SECTION 75 W APPLICATION - ACCESSIBILITY REVIEW

Commercial and Retail Development

100 Mount Street, North Sydney

Report No: AN09015 Cap Stat Report

GROUND FLOOR PLAN

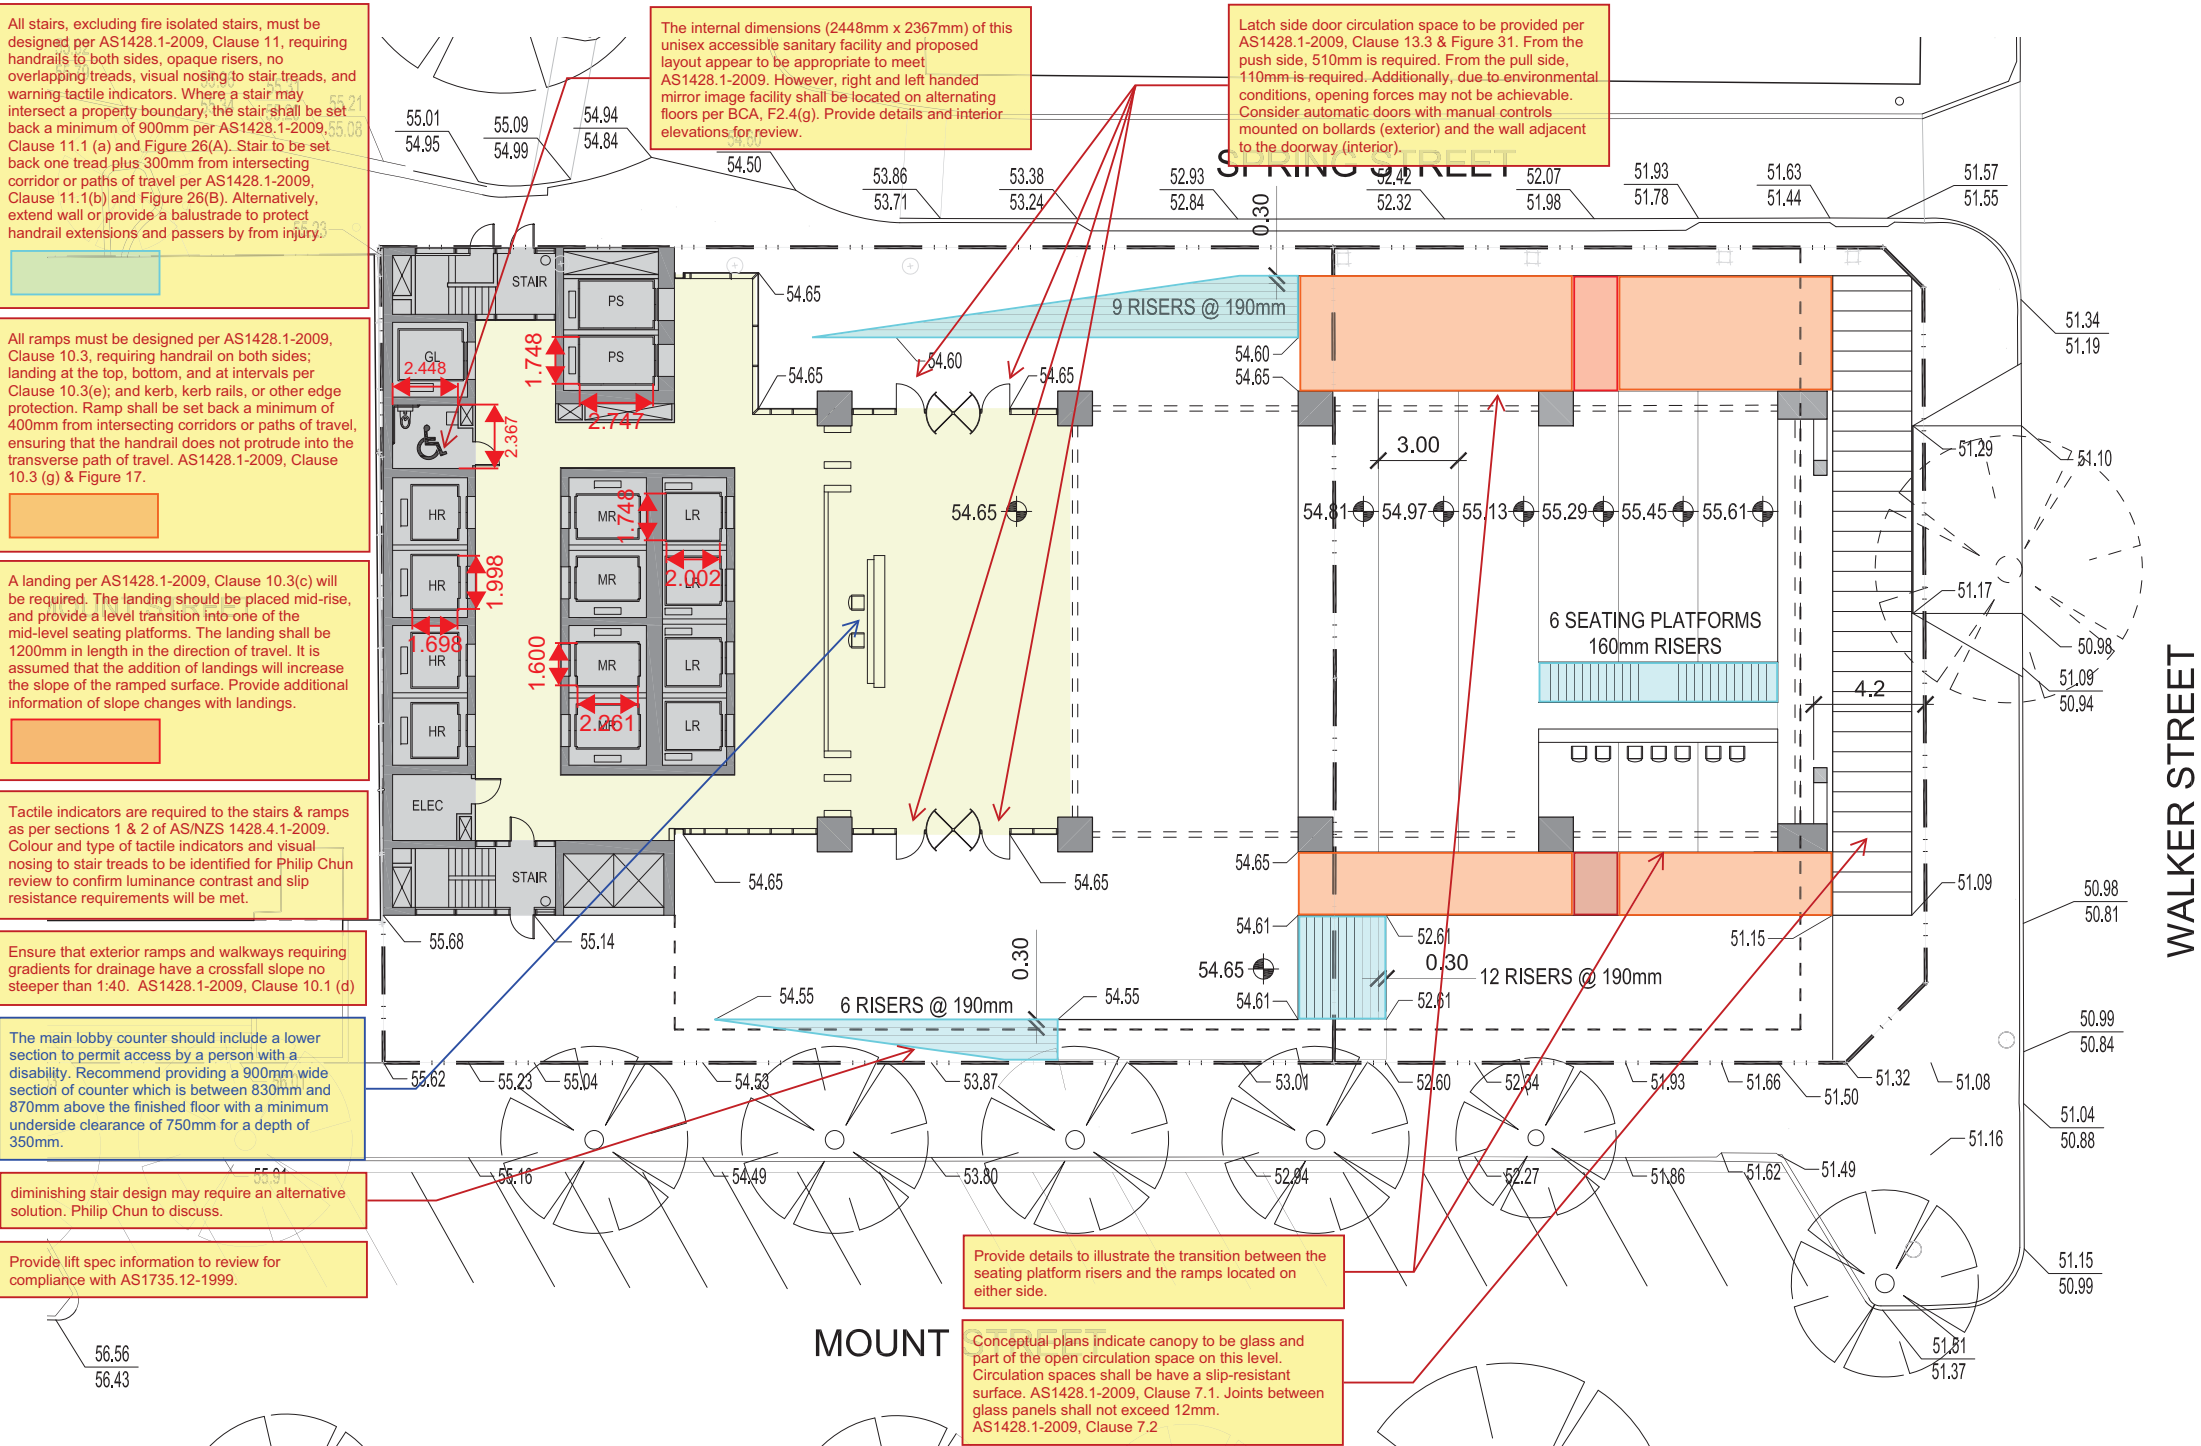
All stairs, excluding fire isolated stairs, must be designed per AS1428.1-2009, Clause 11, requiring handrails to both sides, opaque risers, no overlapping treads, visual nosing to stair treads, and warning tactile indicators. Where a stair may intersect a property boundary, the stair shall be set back a minimum of 900mm per AS1428.1-2009, Clause 11.1 (a) and Figure 26(A). Stair to be set back one tread plus 300mm from intersecting corridor or paths of travel per AS1428.1-2009, Clause 11.1(b) and Figure 26(B). Alternatively, extend wall or provide a balustrade to protect handrail extensions and passers by from injury.

All ramps must be designed per AS1428.1-2009, Clause 10.3, requiring handrail on both sides; landing at the top, bottom, and at intervals per Clause 10.3(e); and kerb, curb rails, or other edge protection. Ramp shall be set back a minimum of 400mm from intersecting corridors or paths of travel, ensuring that the handrail does not protrude into the transverse path of travel. AS1428.1-2009, Clause 10.3 (g) & Figure 17.

A landing per AS1428.1-2009, Clause 10.3(c) will be required. The landing should be placed mid-rise, and provide a level transition into one of the mid-level seating platforms. The landing shall be 1200mm in length in the direction of travel. It is assumed that the addition of landings will increase the slope of the ramped surface. Provide additional information of slope changes with landings.

The main lobby counter should include a lower section to permit access by a person with a disability. Recommend providing a 900mm wide section of counter which is between 830mm and 870mm above the finished floor with a minimum underside clearance of 750mm for a depth of 350mm.

diminishing stair design may require an alternative solution. Philip Chun to discuss.

Provide lift spec information to review for compliance with AS1735.12-1999.

The internal dimensions (2448mm x 2367mm) of this unisex accessible sanitary facility and proposed layout appear to be appropriate to meet AS1428.1-2009. However, right and left handed mirror image facility shall be located on alternating floors per BCA, F.2.4(g). Provide details and interior elevations for review.

Latch side door circulation space to be provided per AS1428.1-2009, Clause 13.3 & Figure 31. From the push side, 510mm is required. From the pull side, 110mm is required. Additionally, due to environmental conditions, opening forces may not be achievable. Consider automatic doors with manual controls mounted on bollards (exterior) and the wall adjacent to the doorway (interior).

Provide details to illustrate the transition between the seating platform risers and the ramps located on either side.

Conceptual plans indicate canopy to be glass and part of the open circulation space on this level. Circulation spaces shall have a slip-resistant surface. AS1428.1-2009, Clause 7.1. Joints between glass panels shall not exceed 12mm. AS1428.1-2009, Clause 7.2

RETAIL LEVEL PLAN

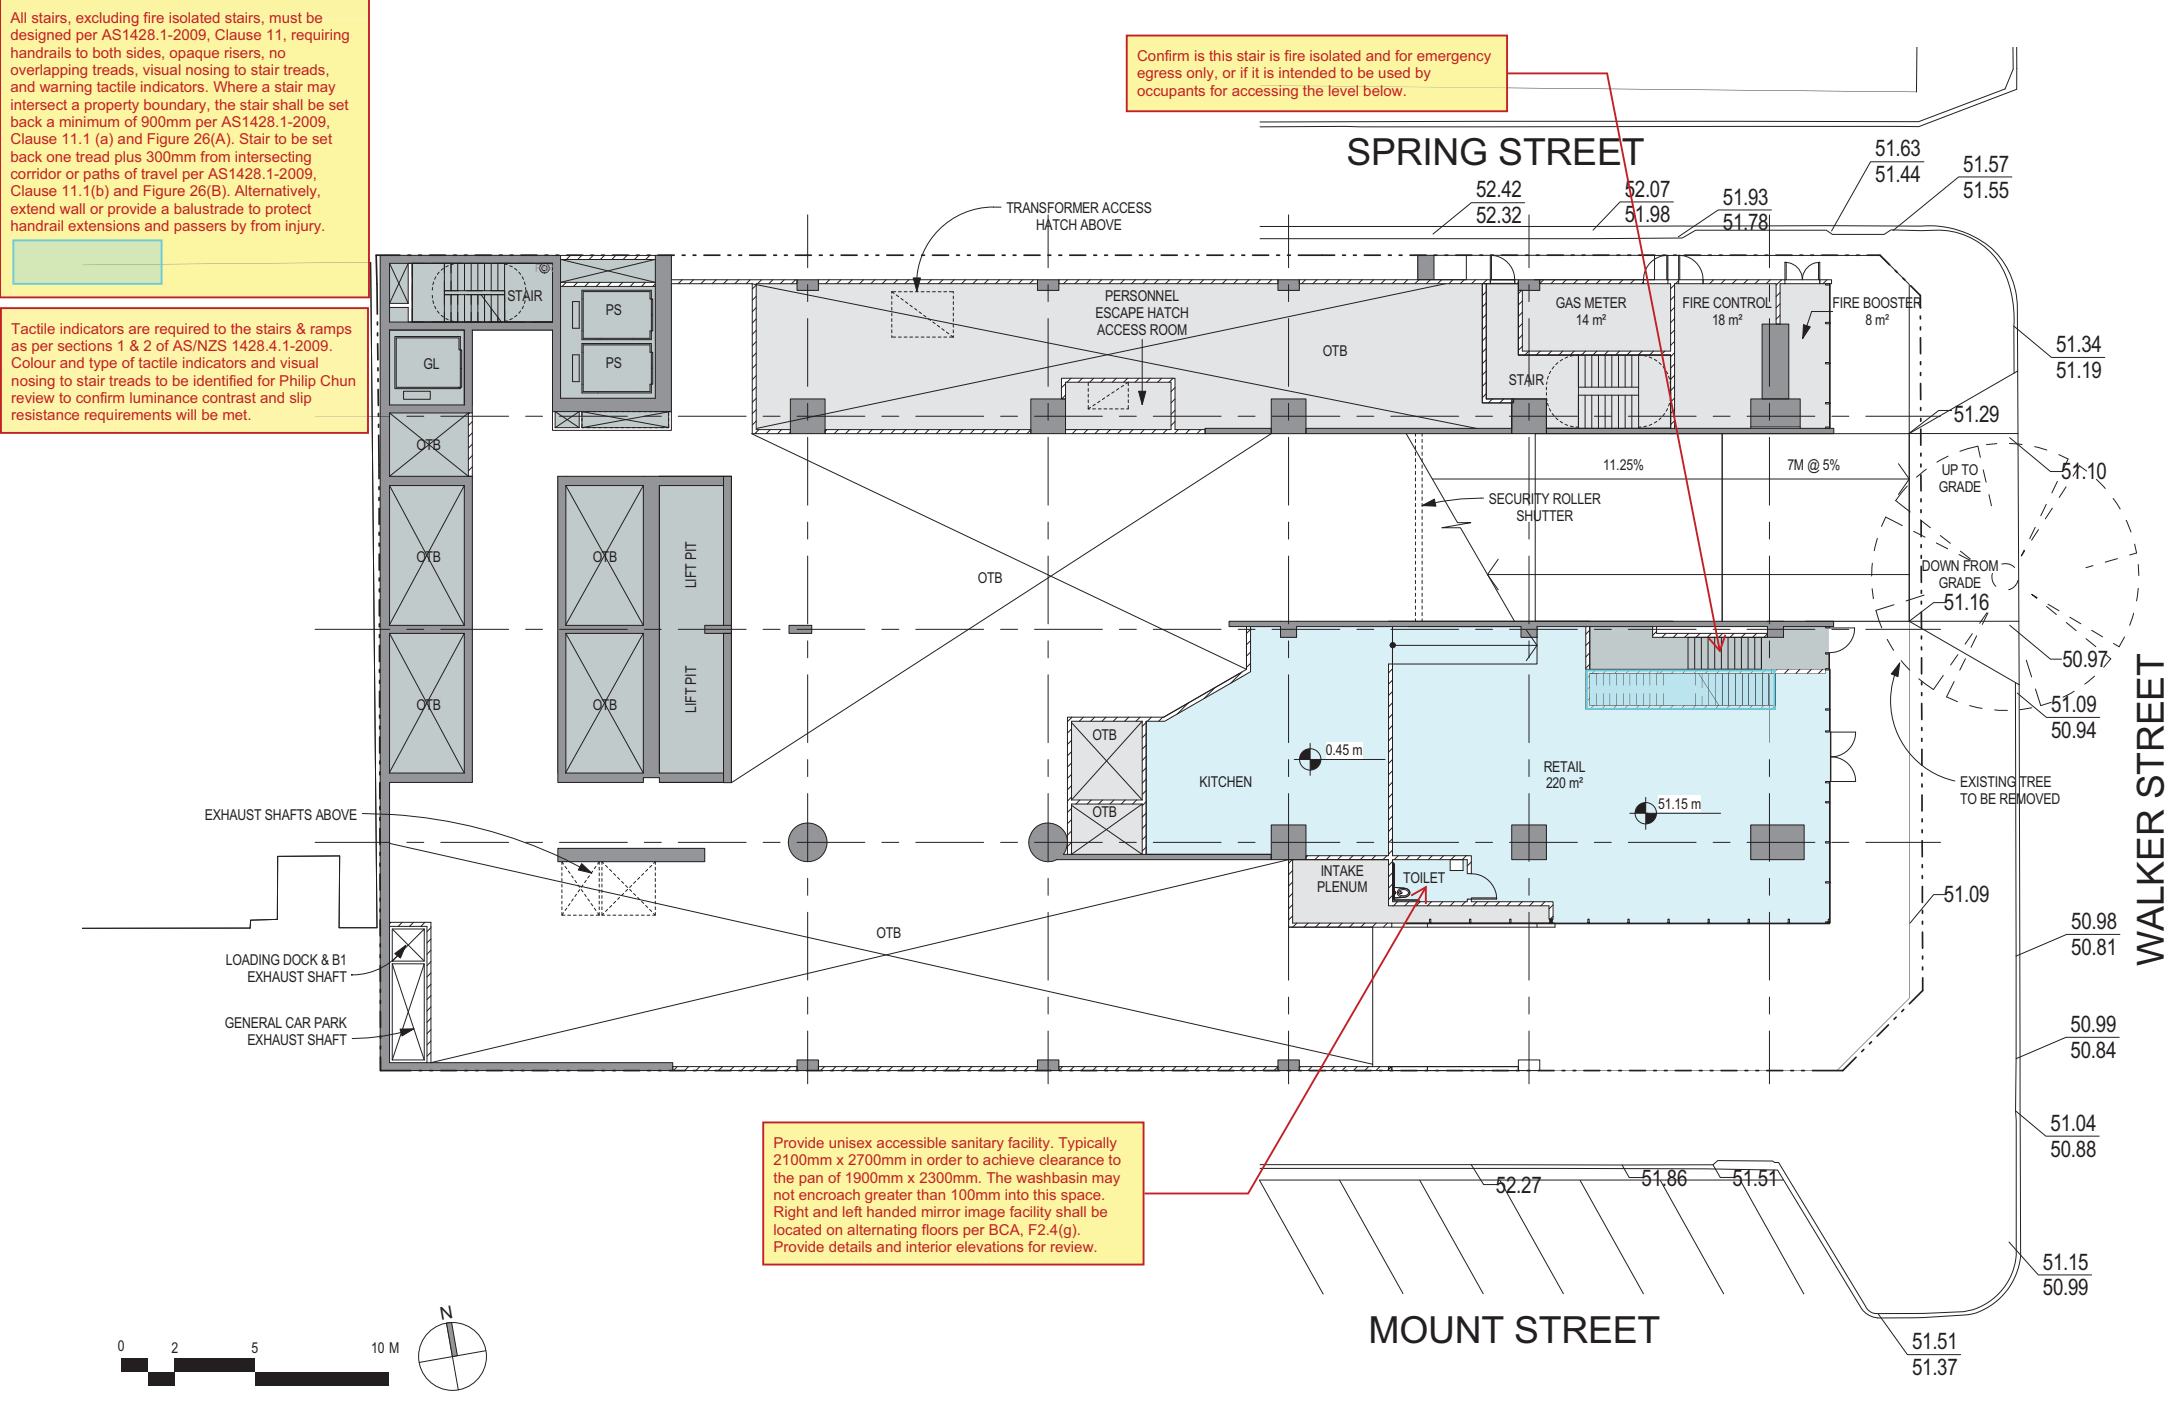
All stairs, excluding fire isolated stairs, must be designed per AS1428.1-2009, Clause 11, requiring handrails to both sides, opaque risers, no overlapping treads, visual nosing to stair treads, and warning tactile indicators. Where a stair may intersect a property boundary, the stair shall be set back a minimum of 900mm per AS1428.1-2009, Clause 11.1 (a) and Figure 26(A). Stair to be set back one tread plus 300mm from intersecting corridor or paths of travel per AS1428.1-2009, Clause 11.1(b) and Figure 26(B). Alternatively, extend wall or provide a balustrade to protect handrail extensions and passers by from injury.

Tactile indicators are required to the stairs & ramps as per sections 1 & 2 of AS/NZS 1428.4.1-2009. Colour and type of tactile indicators and visual nosing to stair treads to be identified for Philip Chun review to confirm luminance contrast and slip resistance requirements will be met.

Confirm is this stair is fire isolated and for emergency egress only, or if it is intended to be used by occupants for accessing the level below.

Provide unisex accessible sanitary facility. Typically 2100mm x 2700mm in order to achieve clearance to the pan of 1900mm x 2300mm. The washbasin may not encroach greater than 100mm into this space. Right and left handed mirror image facility shall be located on alternating floors per BCA, F2.4(g). Provide details and interior elevations for review.

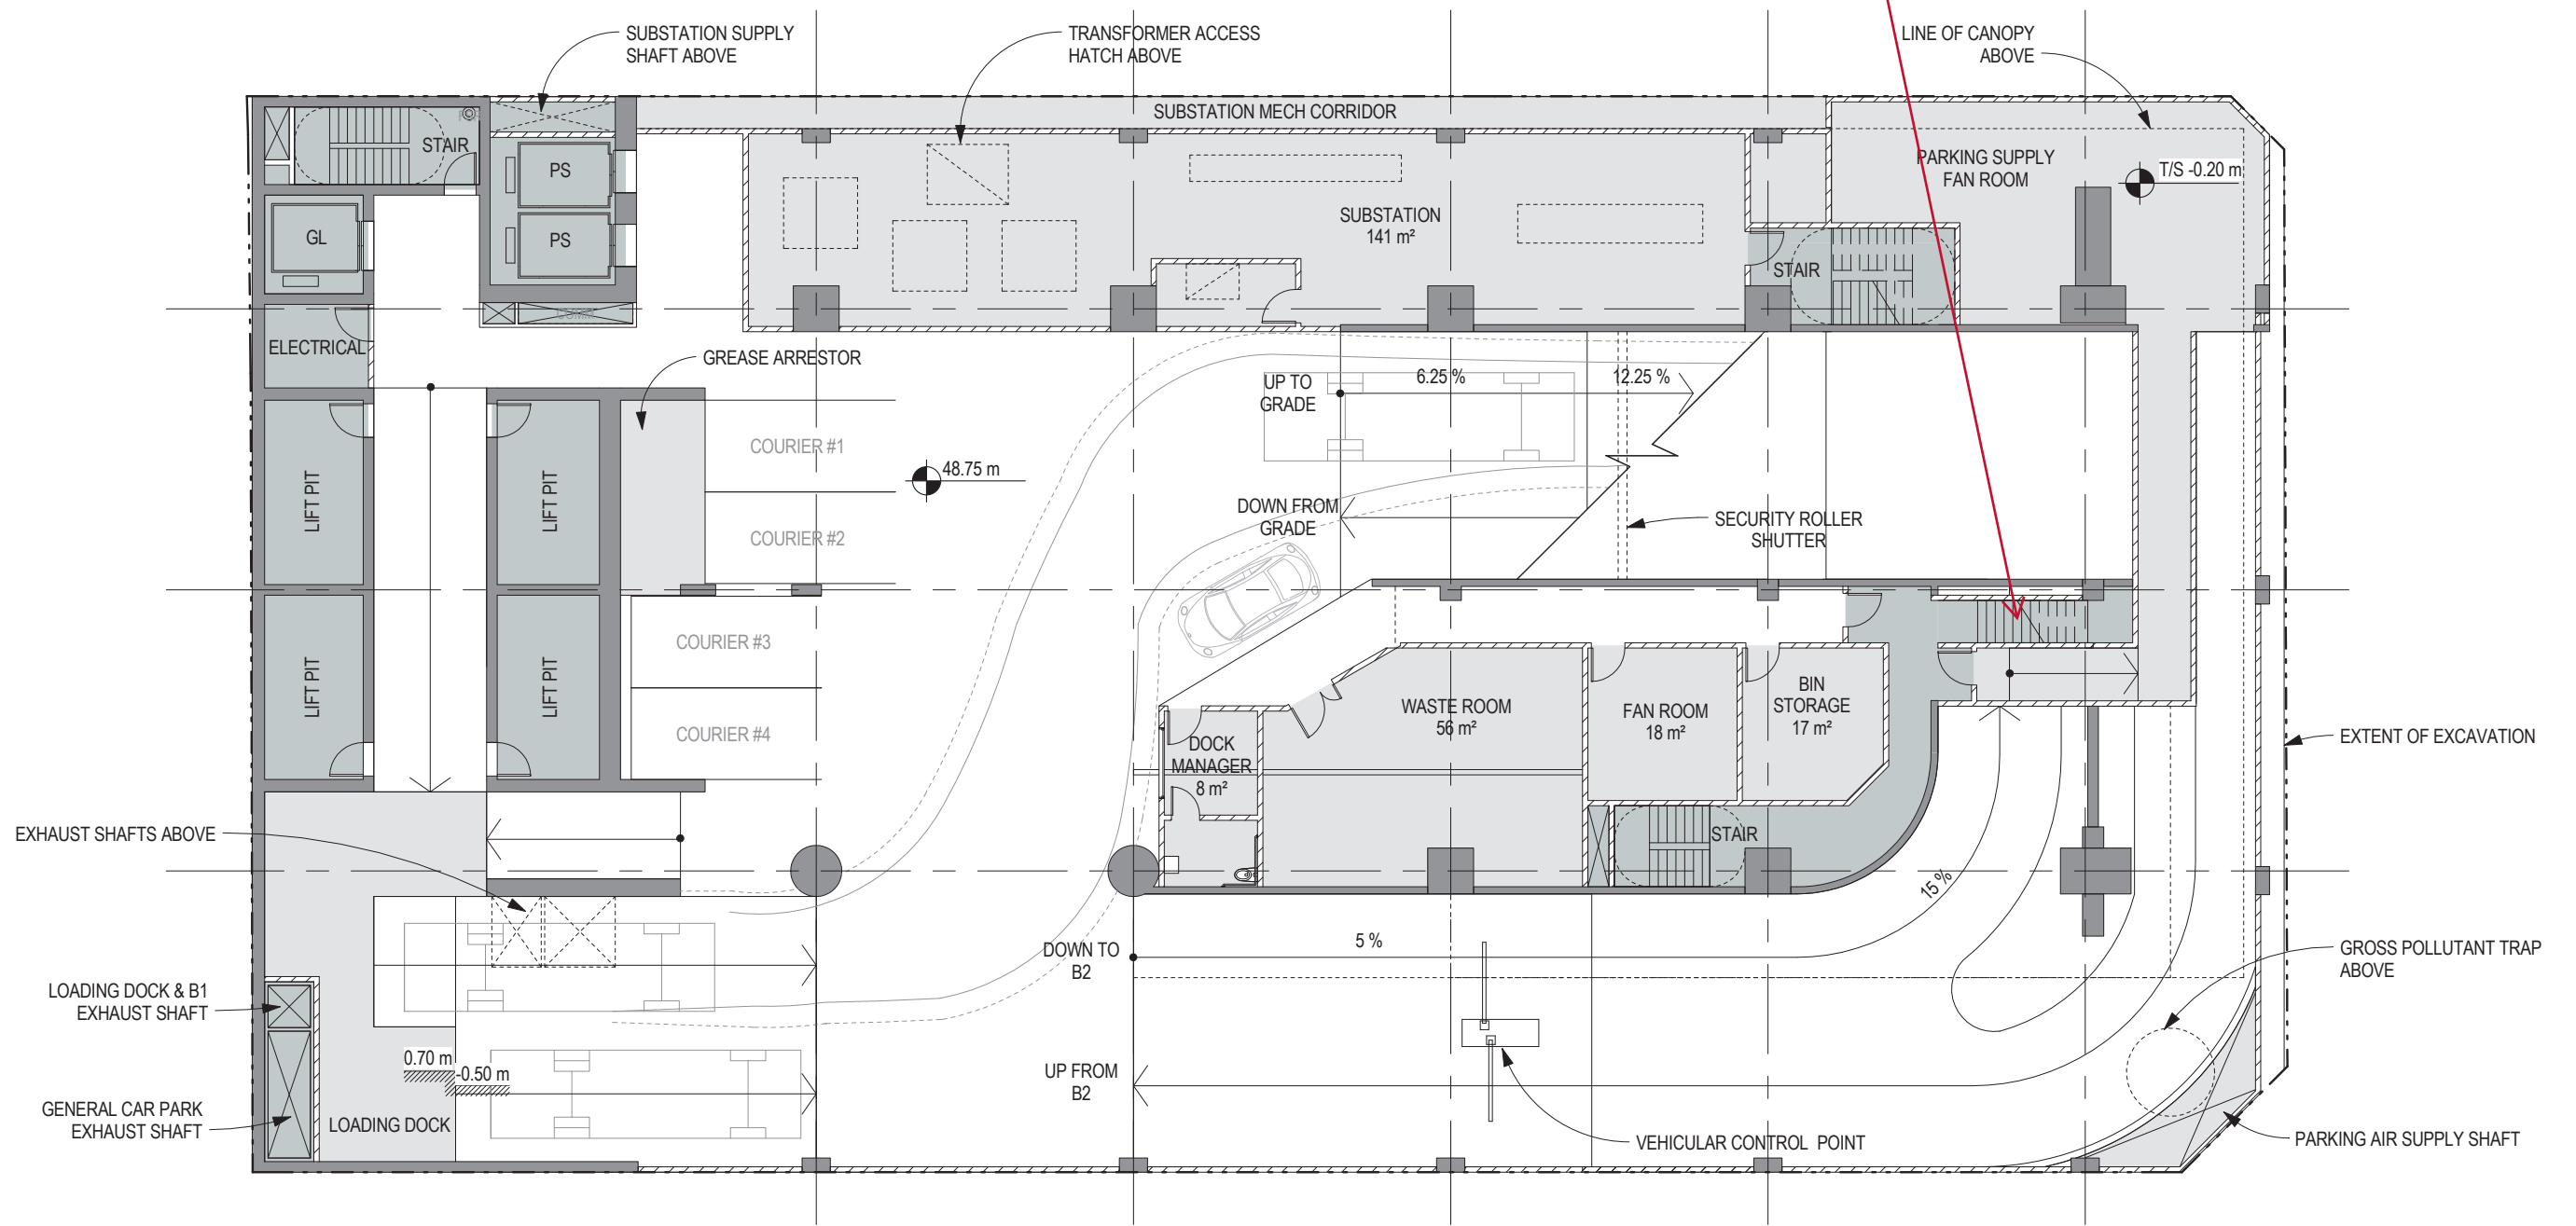
Confirm is this stair is fire isolated and for emergency egress only, or if it is intended to be used by occupants for accessing the level below.
